**Docket:** NRC-2018-0155

Instructions for Completing NRC's Uniform Low-Level Radioactive Waste Manifest

Docket NRC-2018-0155 Comments Rev 1 Glen Vickers Exelon Generation

**Comments for NRC-2018-0155, NUREG/BR-0204 Instructions for Completing the US Nuclear Commission's Uniform Low-Level Radioactive Waste Manifest**

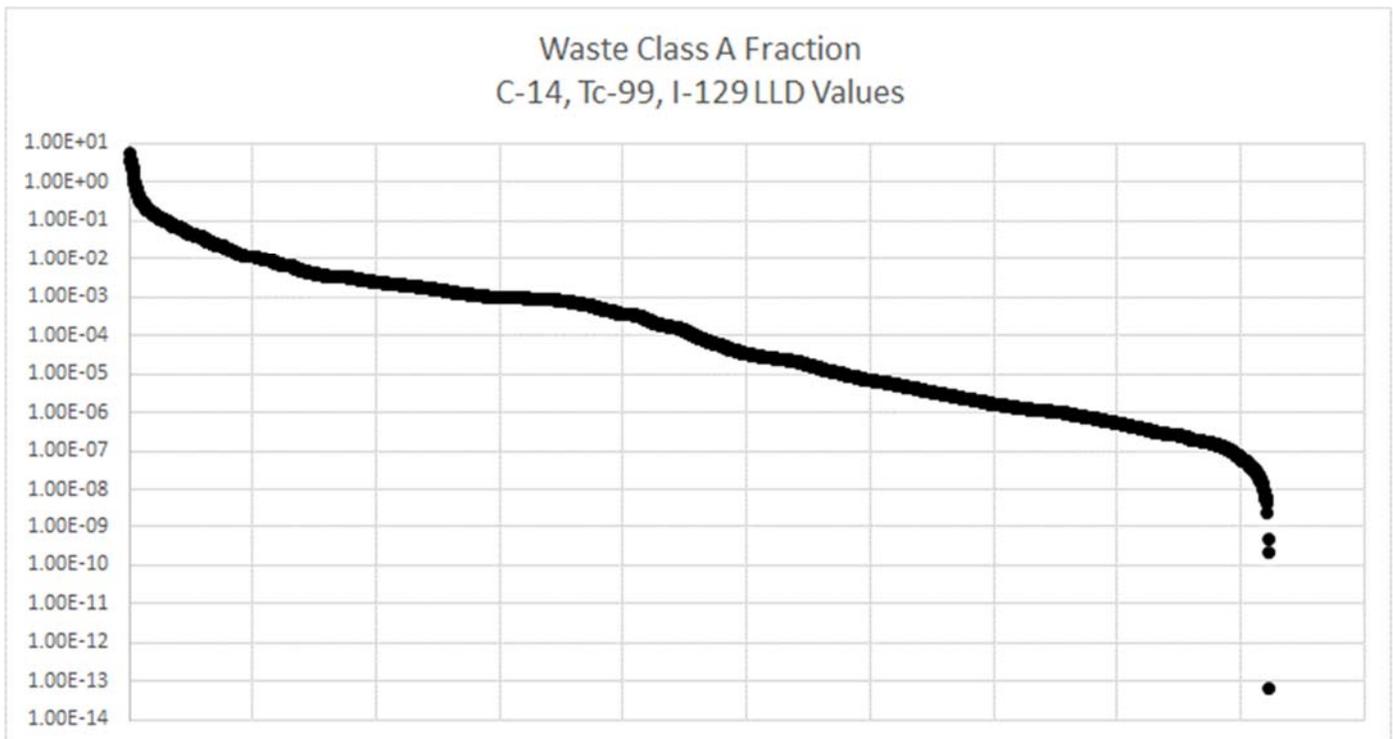
The current NUREG clearly separates LLD values from measured activity values or indirectly scaled activity values derived from actual measurements. The proposed language would convert LLD values to activity to be added to the directly measured and indirectly scaled activity. This conflicts with 10CFR61 and further clarification in NRC Waste Class and Form BTP 1983. This would also conflict with state regulations and associated disposal site WACs as they are also based upon 10CFR61. NRC IN 86-20 further discusses issues with waste classification, indirectly scaled measurements, and potential sources of error and at no point suggests the use of LLD values as real values.

Regulation 10CFR61(a)(8) discusses actual waste concentrations and indirectly scaled values from other measured values for waste classification, but LLD values which are not measured values are not part of the activity for the waste. The NRC Waste Class and Form BTP 1983 page 8, states, "If the radionuclide is determined through material accountability, direct measurement, inference through direct measurement, or gross radioactivity measurement, this quantity should be reported as determined...Radionuclides <LLD values are recorded separately in parenthesis". Converting inflated LLD values to real values has no technical basis and would improperly inflate waste class and other regulatory fractions. This constitutes a conflict with 10CFR61. Radionuclides which are <LLD are not measured and not included in waste classification or other supporting regulatory fractions.

The current NUREG clearly separates determined values from LLD values and LLD values have no impact upon shipment activity, waste classification, or other regulatory fractions. It is recommended that no change be made to the current logic.

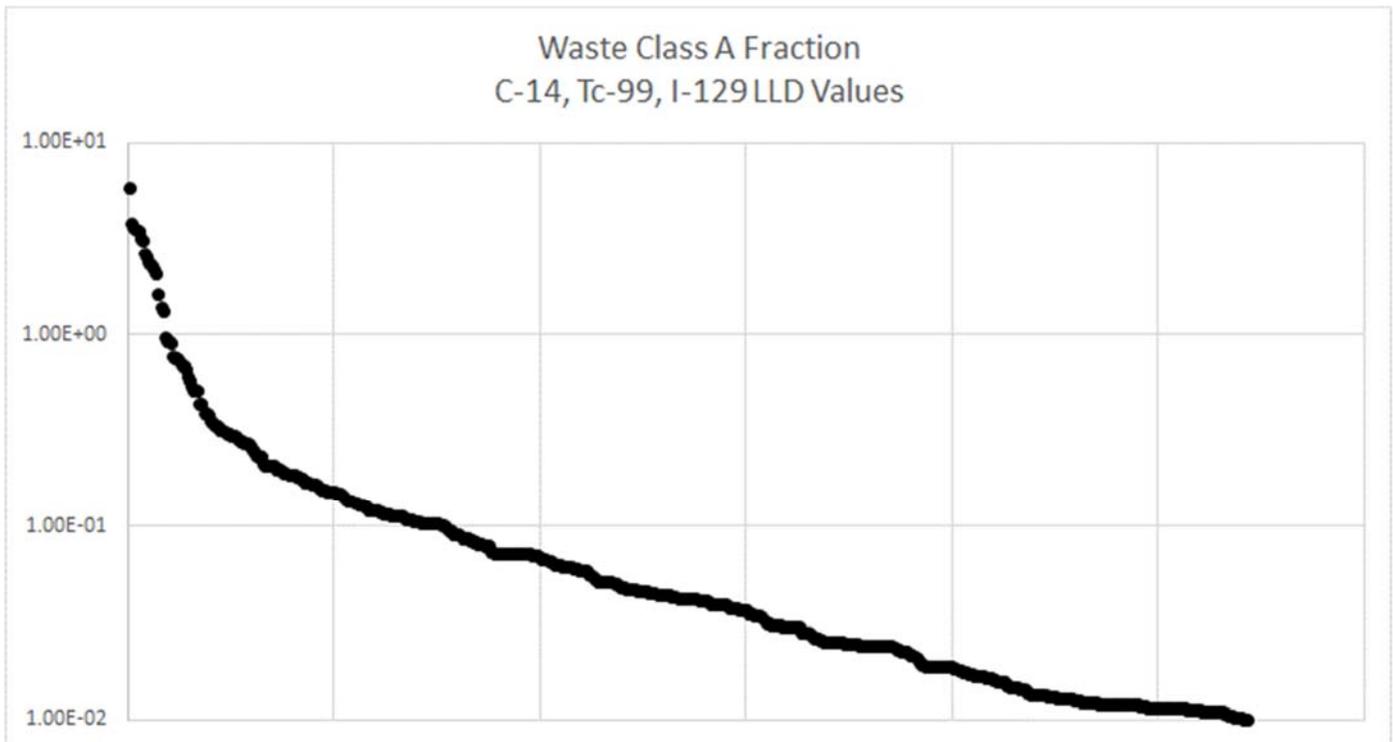
The following figure contains data from 4608 packages from 8 power plants (3 PWR, 5 BWR). The data is the waste class fraction if C-14, Tc-99, and I-129 were converted to real values for the purposes of waste classification and supporting regulatory fractions as suggested.

There are 544 of 4608 packages where the impact would exceed 1% of the Waste Class A limit.

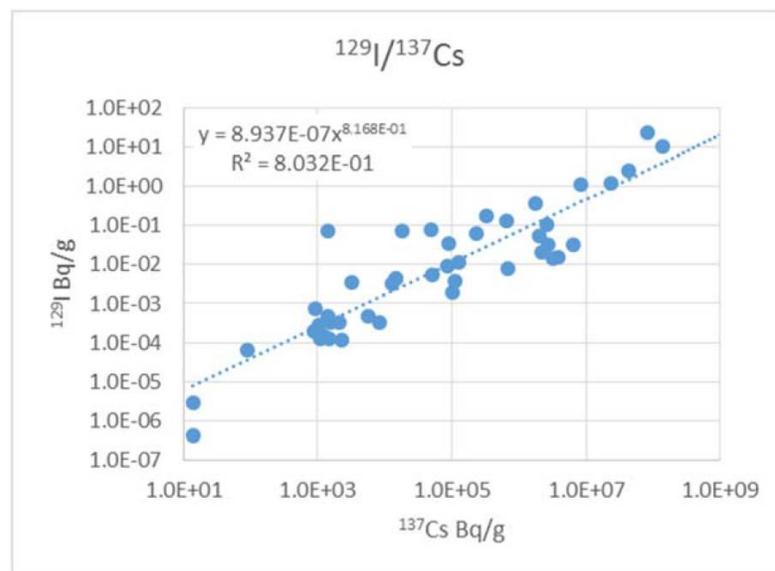
The current NUREG does not try to differentiate between direct measurements and indirectly scaled activity based upon measurements because they are considered to be “determined” or “real” activity values. This once again conflicts with 10CFR61 and NRC Waste Class and Form BTP 1983. Additionally, most of the radionuclides on a shipping paper are determined indirectly from measurements (e.g. H-3, C-14, Fe-55, Ni-59, Ni-63, Sr-89, Sr-90, Nb-94, Am-241, Pu-238, Pu-239, Pu-241, Cm-242, Cm-244). There should be no action to attempt to differentiate values which are already considered to be “determined” values.

The radionuclides of true interest are H-3, C-14, Tc-99, and C-14. Indirect scaling factors to other measurements can easily be determined for H-3 and C-14. The radionuclides Tc-99 and I-129 are always <LLD, so shippers have no mechanism to calculate a scaling factor which would meet the reasonable assurance clause of 10CFR61(a)(8) and supporting regulatory guidance. The LLD value currently becomes scaled to a measurable base radionuclide such as Co-60 or Cs-137 and is reported on the manifest as an LLD value.

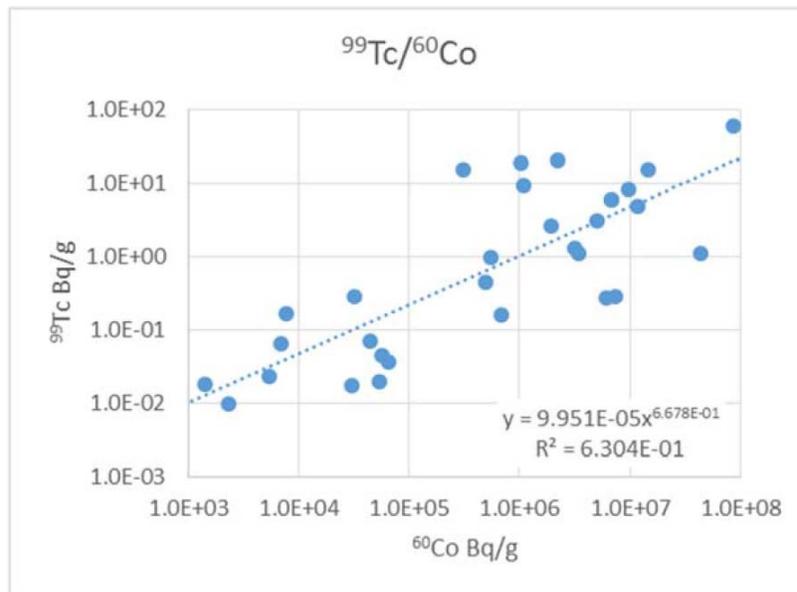
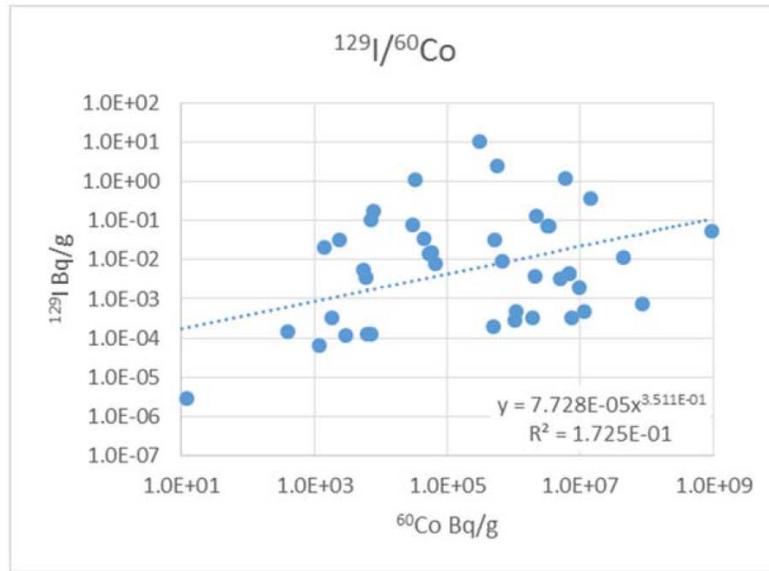
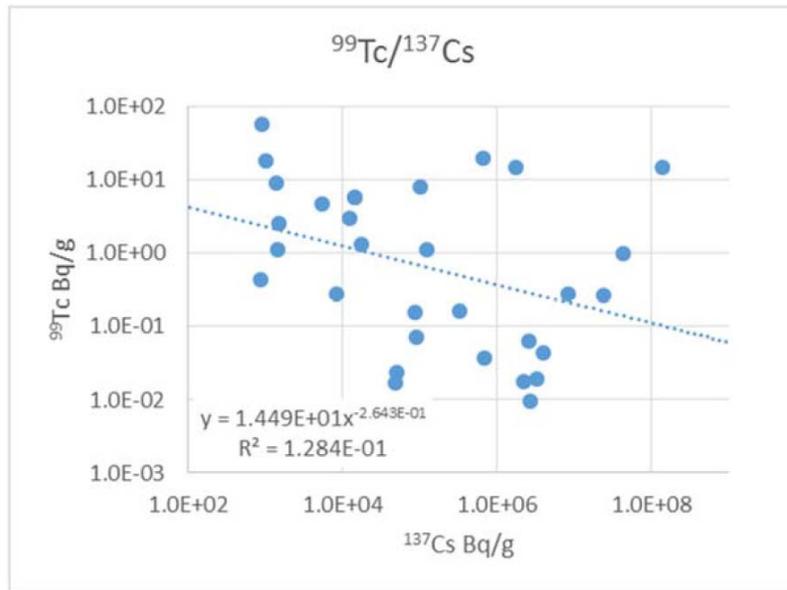
The draft NUREG points to logic from RIS-2015-02 for indirectly scaled values for H-3, C-14, Tc-99, and I-129. RIS-2015-02 was incorrect in stating that the use of indirectly scaled activity was not permitted. Regulation 10CFR61 and supporting regulatory guidance consider both directly measured values and indirectly scaled values from measurements to both be “determined” values for the purposes of reporting activity and waste classification. NRC Waste Class and Form BTP 1983 further clarifies, “If the radionuclide is determined through material accountability, direct measurement, inference through direct measurement, or gross radioactivity measurement, this quantity should be reported as determined”. The current NUREG is correct when it says report the activity and LLD values separately in parentheses, since directly measured and indirectly scaled values are the same.

It is recommended that no changes be made with the reporting of determined values (e.g. material accountability, direct measurement, inference through direct measurement, or gross radioactivity measurements) and LLD values.

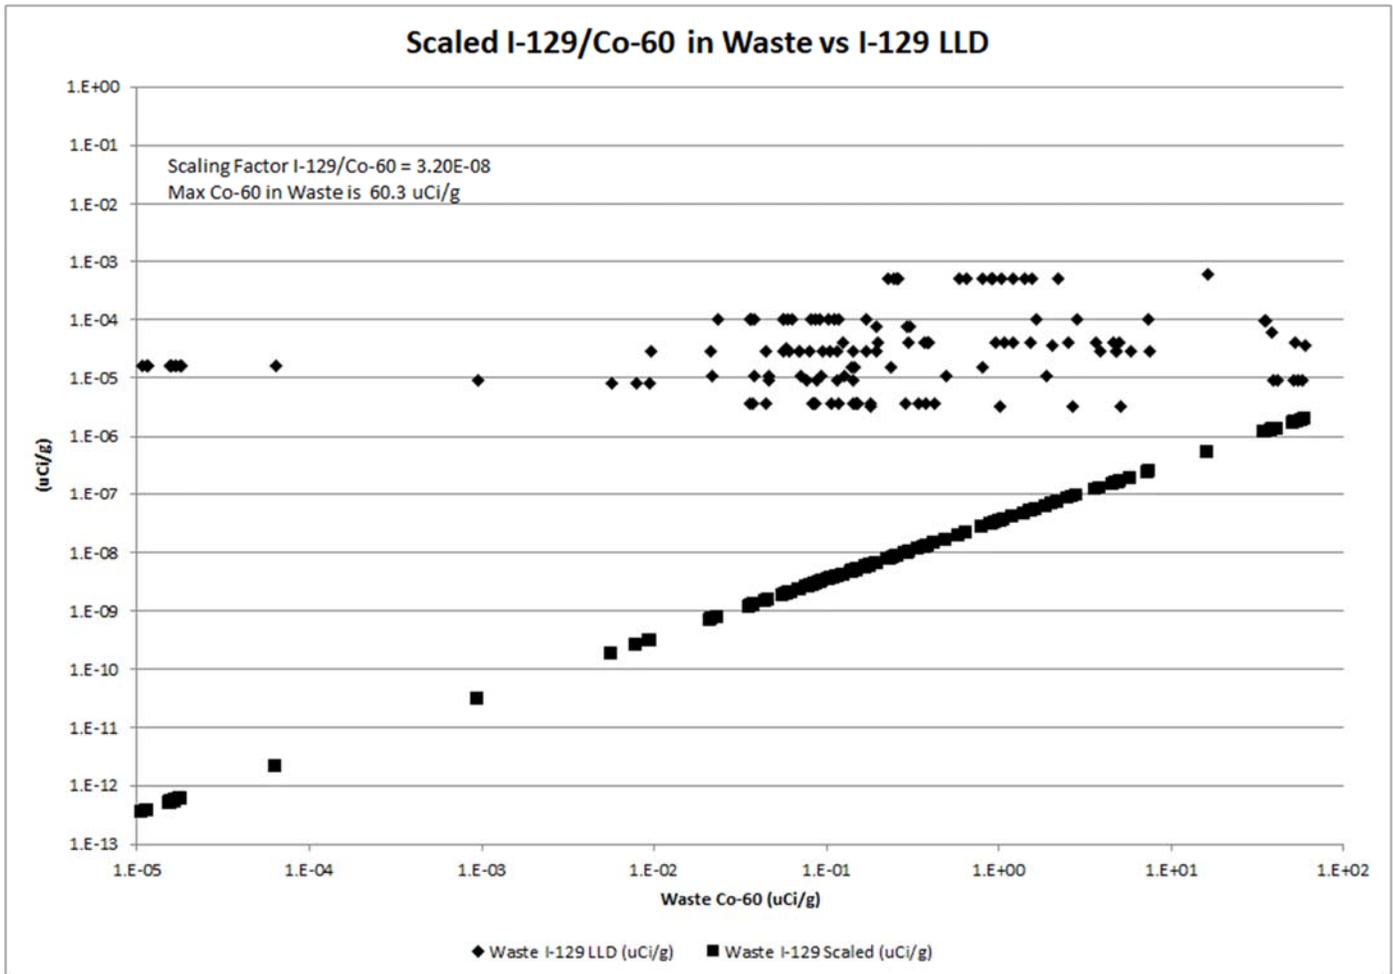
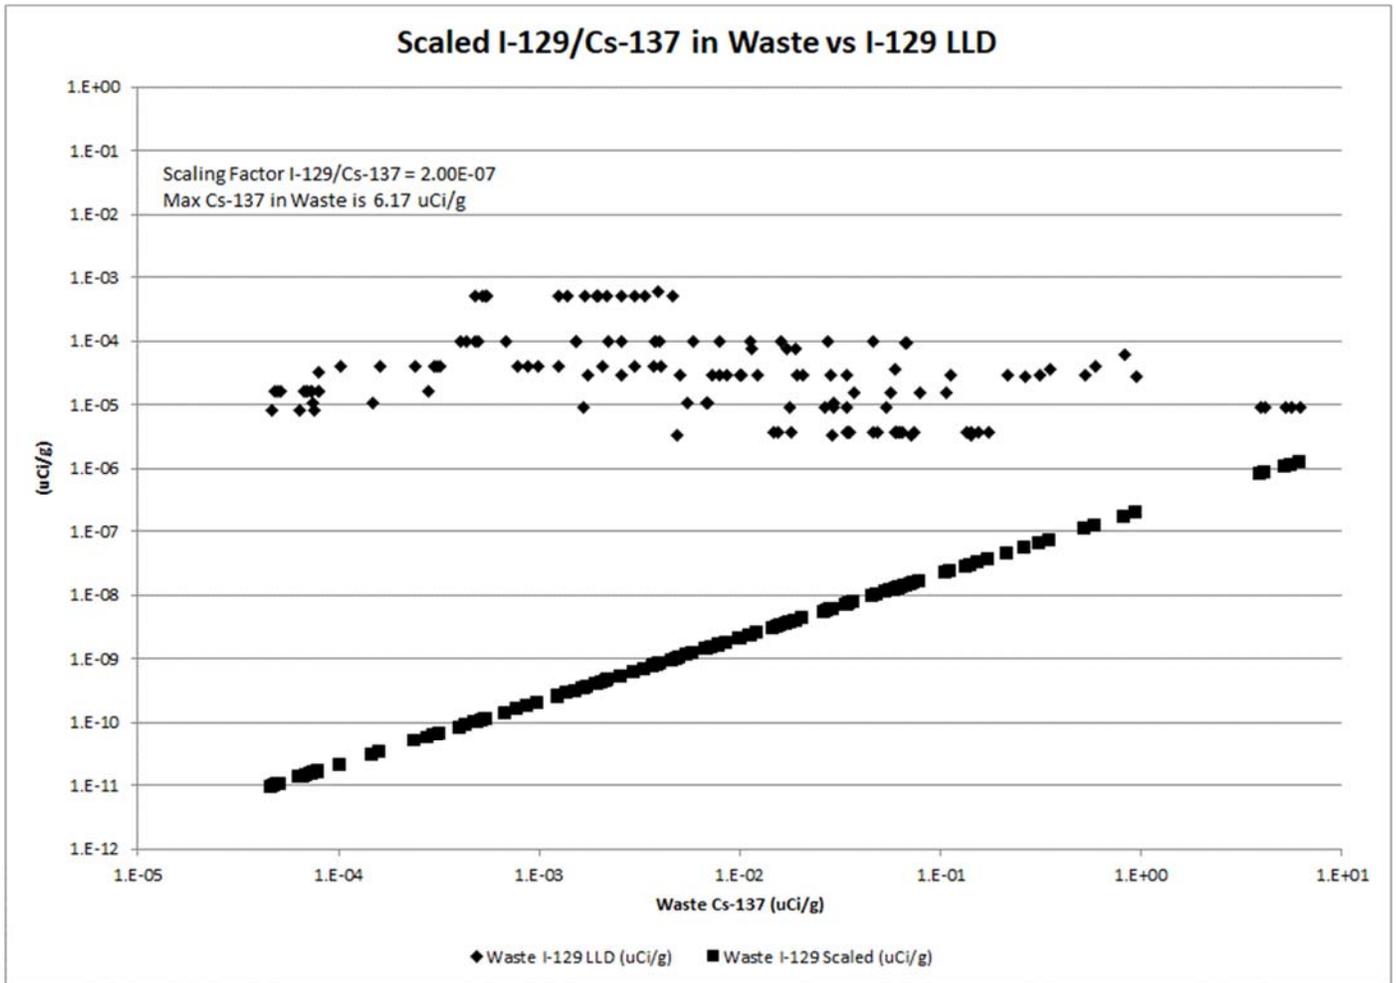
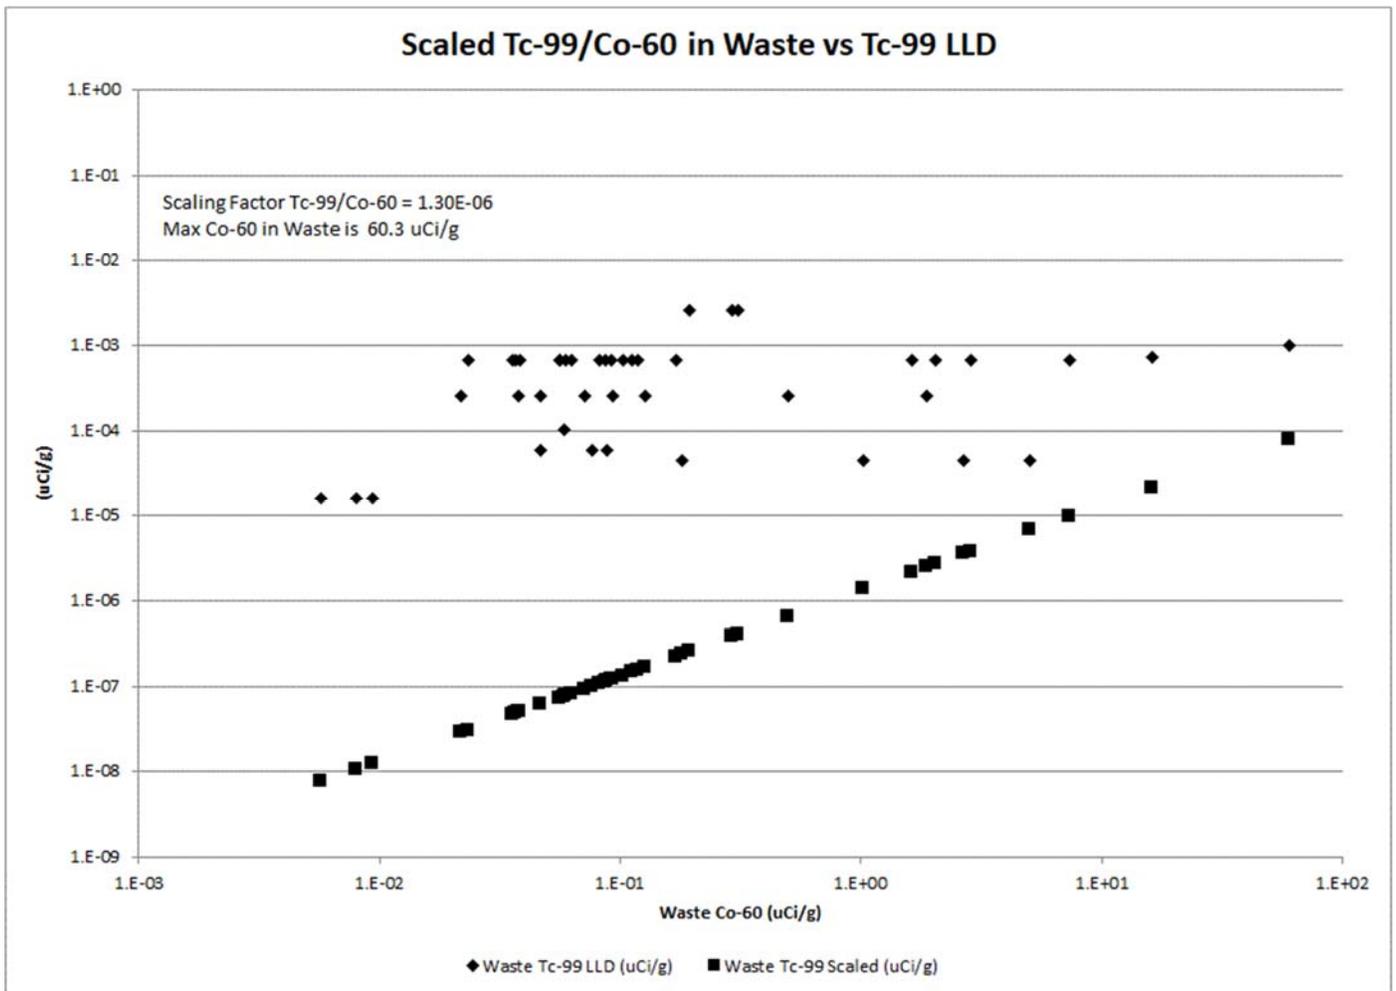
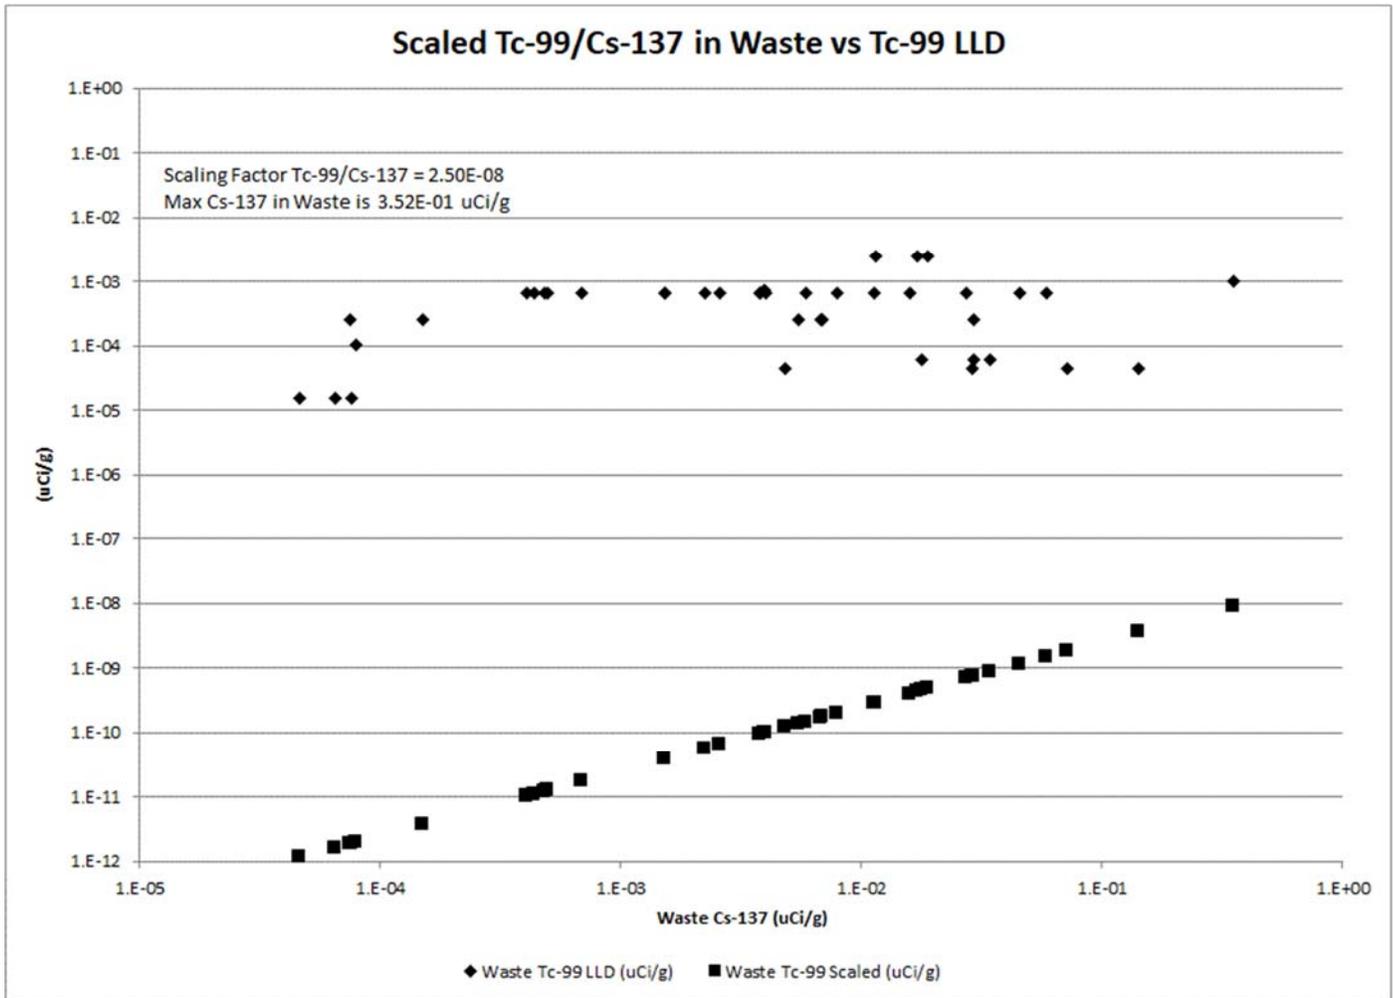
The following figures are from NUREG/CR-6567 and reproduced in the EPRI 2015 work. It is clear there is significant scatter in the data. A factor of 10 is typically applied when comparing an individual data point to the geometric mean of the population when determining if a data point is an outlier and not included in the calculation of a scaling factor. The figures show there are quite a few points that would be outside a factor of 10 of the geometric mean such that there is less certainty of the scaling factor as compared to many other radionuclides with better radiochemical fit.

As previously noted, a shipper would not be able to articulate how their radiochemistry and plant conditions would bound them within this high-scatter data environment within a factor of 10 for a specific waste container. This why the NRC would need to endorse the use of the scaling factors from NUREG/CR-6567 and/or the EPRI 2015 work as best available technology and relieve shippers of the reasonable assurance clause. Otherwise shippers will continue using vendor LLD values.

It is recommended that the NRC endorse the Tc-99 and I-129 scaling factors in NUREG/CR-6567 for use by shippers without further regulatory scrutiny. This would solve everything and there would be no need to alter the current NUREG/BR-0204.
